Mapleton City

Planning Commission Staff Report

Consideration of a Final Plat approval for the Canto Subdivision Plat "B", an amendment of the Canto Subdivision Plat "A" to include two additional lots, located at approximately 600 East Maple Street in the Residential-Minor Agricultural (RA-2) zone.

MAPLETON CITY DEVELOPMENT REVIEW COMMITTEE MINUTES

CANTO SUBDIVISION PLAT "B"

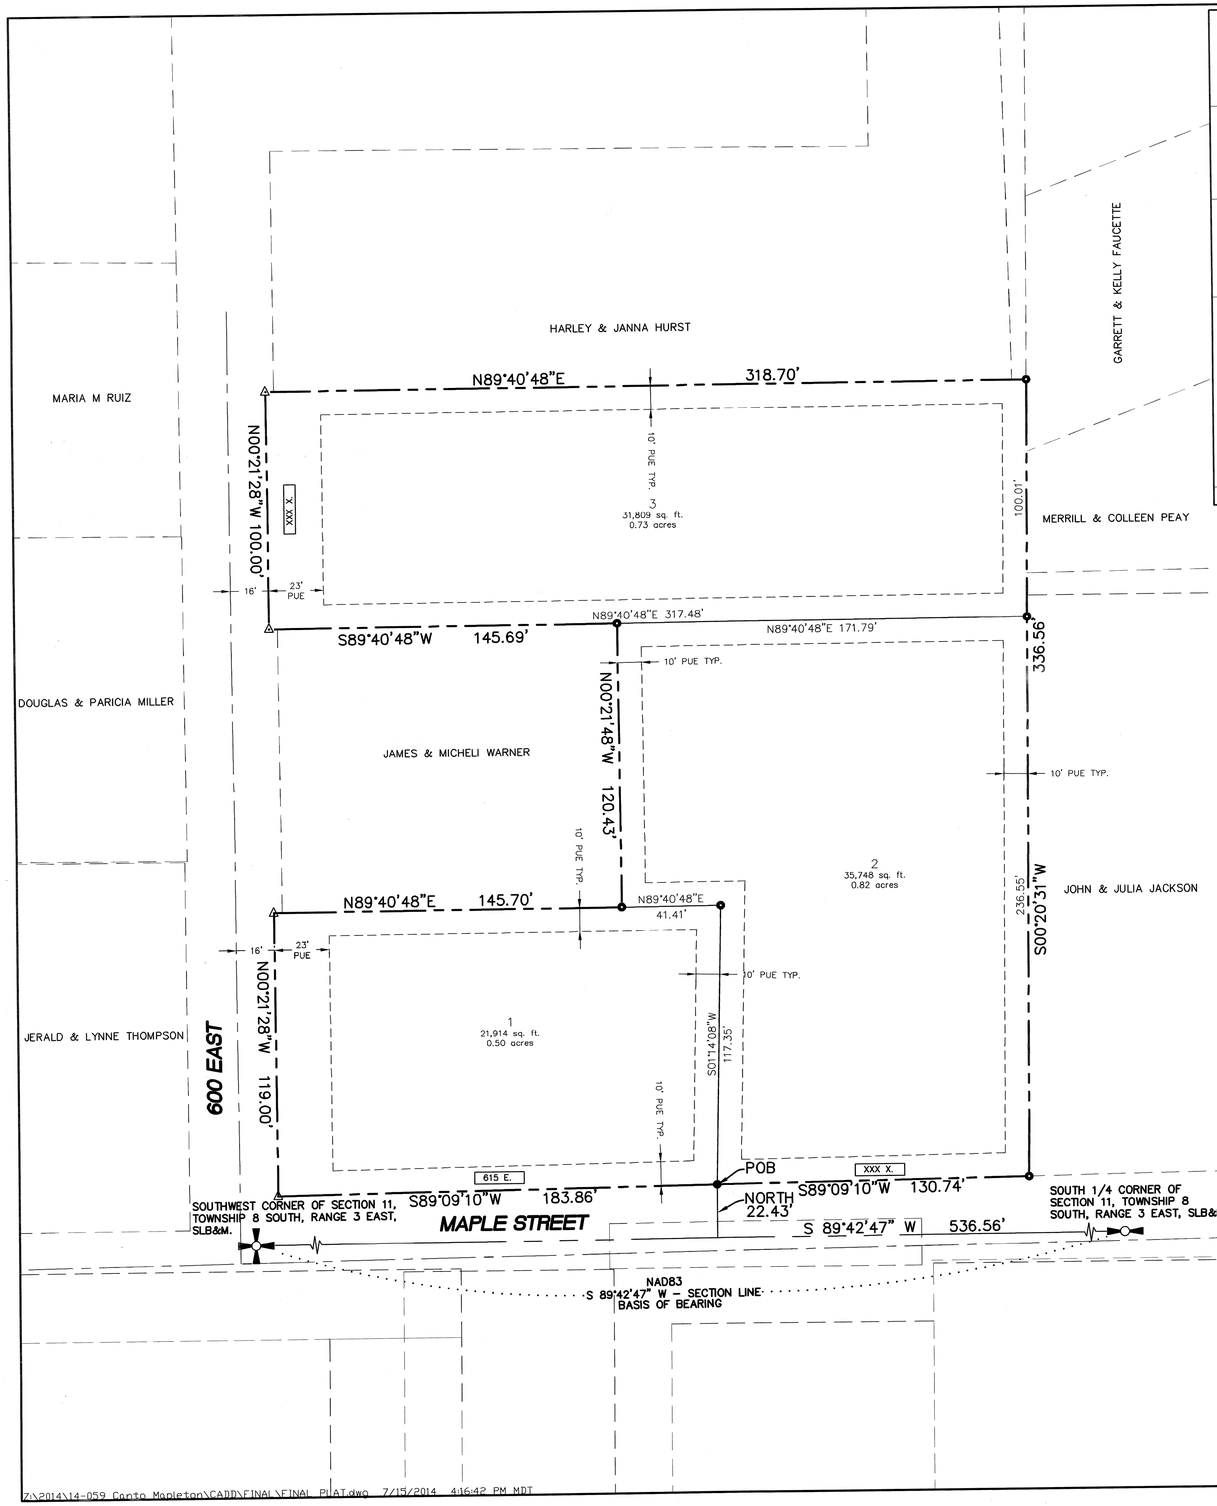
1. The boundary description on the Preliminary Plan includes Lot 1 of the Canto Subdivision Plat "A". As that plat was already approved a new description is needed for Plat "B". Unless there is a change to the dimensions of Lot 1, Plat "A" there is no obvious reason to vacate and amend plat "A".
2. Please include the following addresses on the Final Plat: Lot 2 – 104 N; and Lot 3 – 665 E.
3. Signature blocks/lines must be included for approval by the "Legislative Body" in accordance with state law and Utah County's Requirements. Lines for signatures by the Mayor, City Engineer and City Recorder (to attest) must be included.
4. Signature blocks/lines must be included for approval by the "Planning Commission Approval" in accordance with state law and Utah County's Requirements. Lines for signatures by the Planning Commission Chairman and Community Development Director must be included.

5. The Final Plat must include a line for each notary to print their full name, their commission number and the words "A notary public commissioned in Utah" in the notary public signature block. This is a precaution to prevent issues with illegible notary stamps.
6. Signature blocks/lines for Rocky Mountain Power, Century Link, Comcast, Questar Gas, and Mapleton Irrigation need to be included on the final plat. These utility/service providers/infrastructure owners may have requirements for their respective signatures.

- The project will require approval by the Planning Commission.
- ***Some of the coordinates in the boundary description and on the final plat don't match (see attached). Please correct**.
- Please remove the setback lines on the plats (setbacks are subject to change over time).

SHEET NO.
4

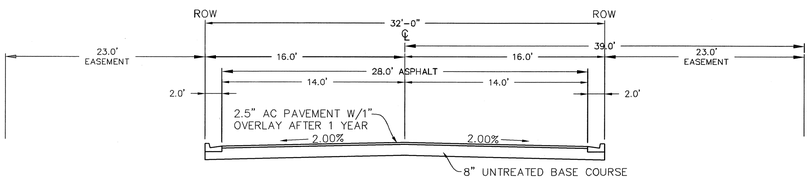
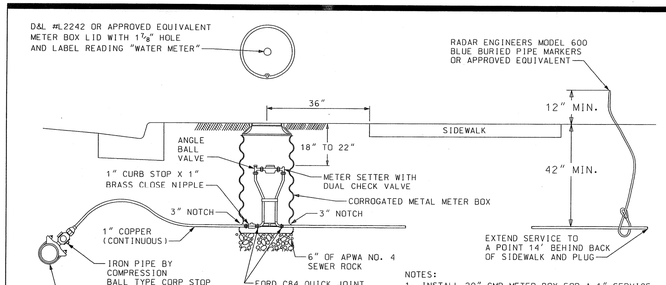
1. Road x-sections:
    a. Maple Street x-section to match existing improvements on Maple Street, not x-section on sheet #4.
    b. *The cross section on sheet #4 should be labeled 600 E. The plat shows a strip on lots 1 and 3 to be dedicated to the City. Using the 32' ROW cross section, it appears that these areas should be shown as a pedestrian and PUE instead of a ROW. Please correct.
2. Bring all concrete improvements to current city standards, including ADA ramps.

PRE-TREATMENT SUMP
MAPLETON CITY STANDARD

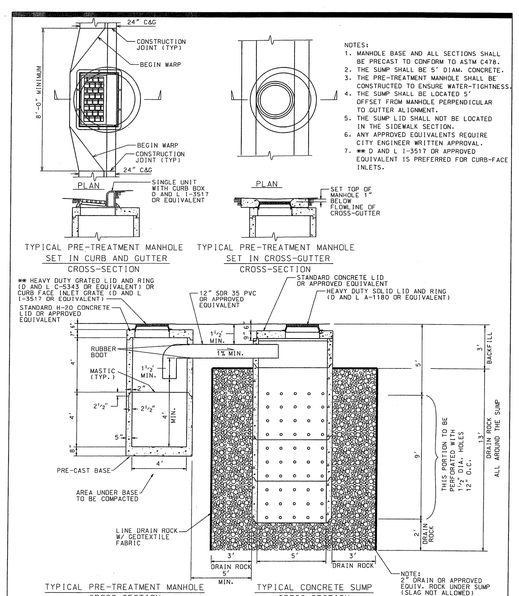
1. Inlet-box and sump shall be meet city standards.
